**TOWN OF STRATFORD  
BID #2016-004**

**ADDENDUM #1  
Issued 2/16/16**

**REHAB OF CANAAN RD & LIGHT ST BRIDGES**

REHABILITATION OF CANAAN ROAD AND LIGHT STREET BRIDGES  
STRATFORD, CONNECTICUT  
February 15, 2016

BRUCES BROOK - STRATFORD CONN.  
 CONCRETE BRIDGE AT CANAAN ROAD  
 Scale 1/2" = 1 foot unless otherwise noted April 1940

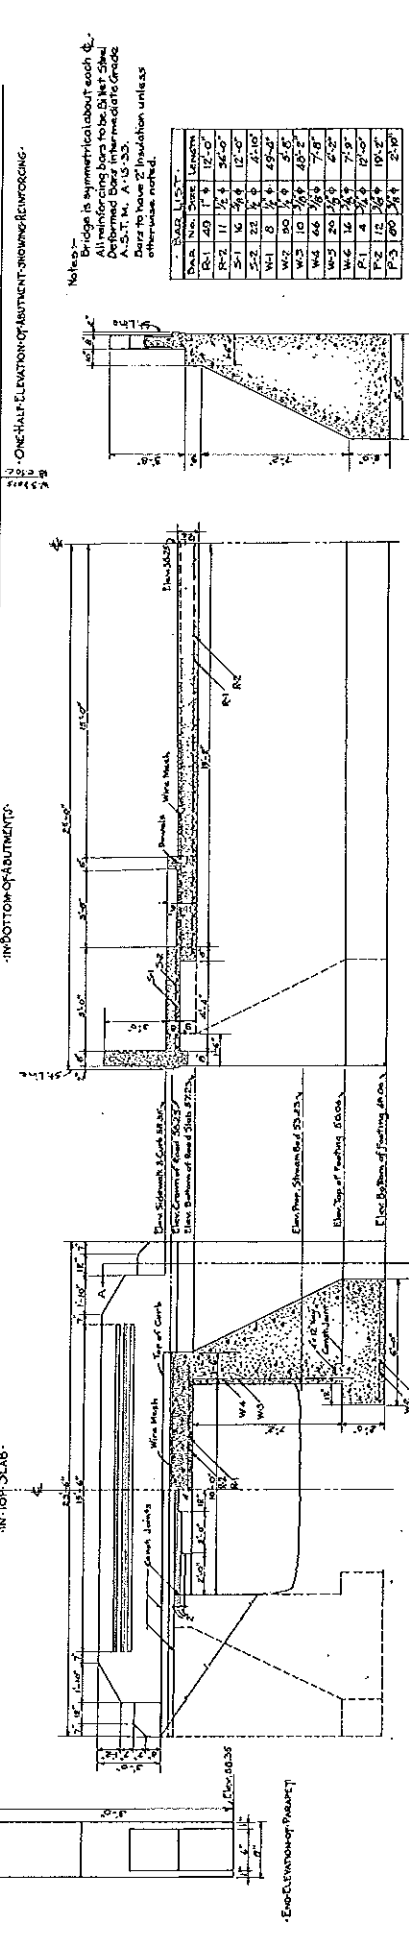
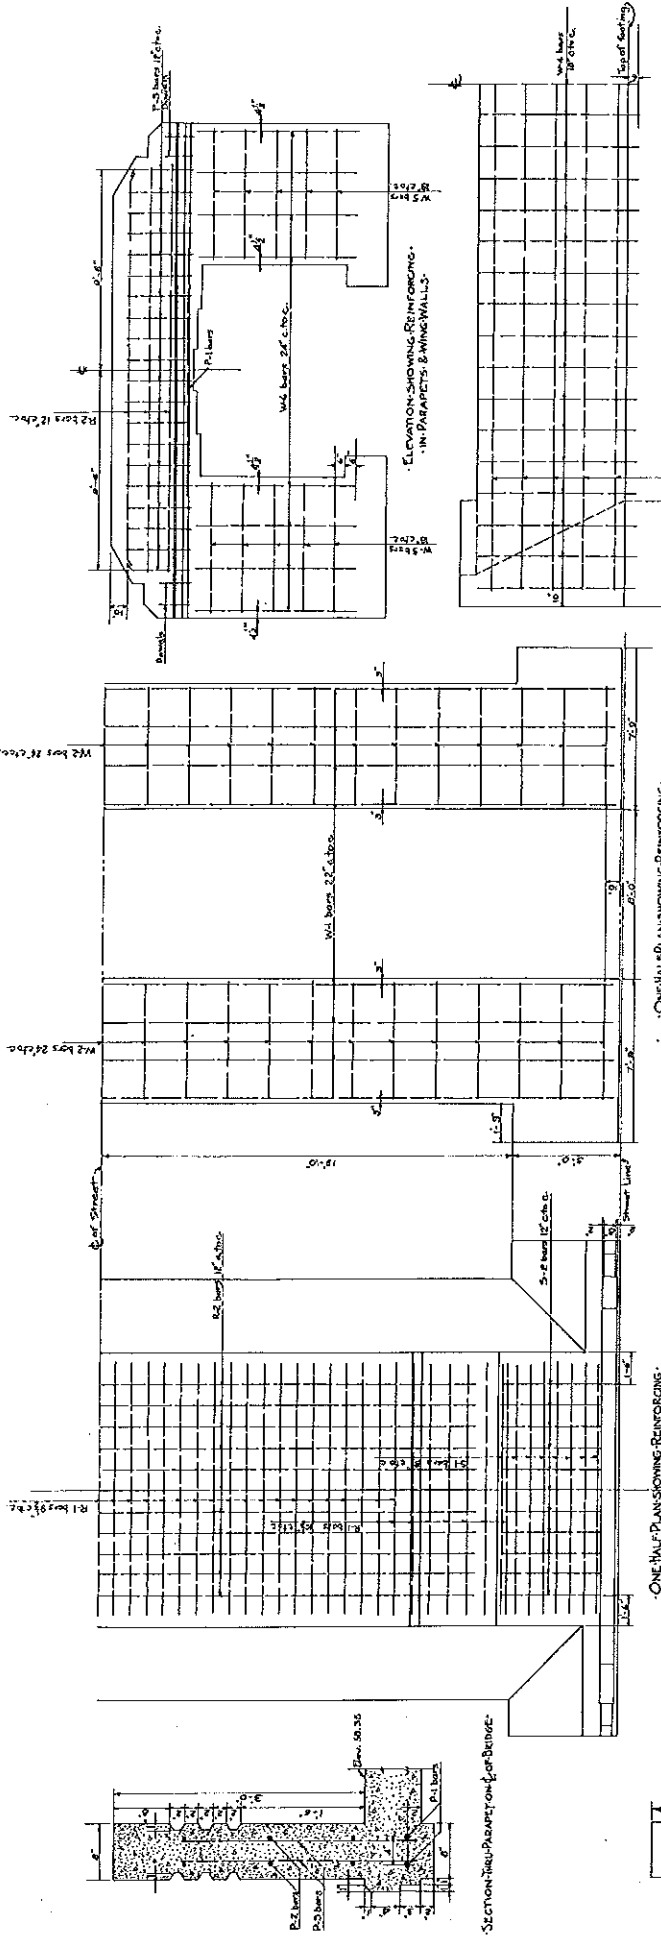
Are there details on how the existing bridge decks are connected to the existing abutments?

*See attached plans for existing construction details.*
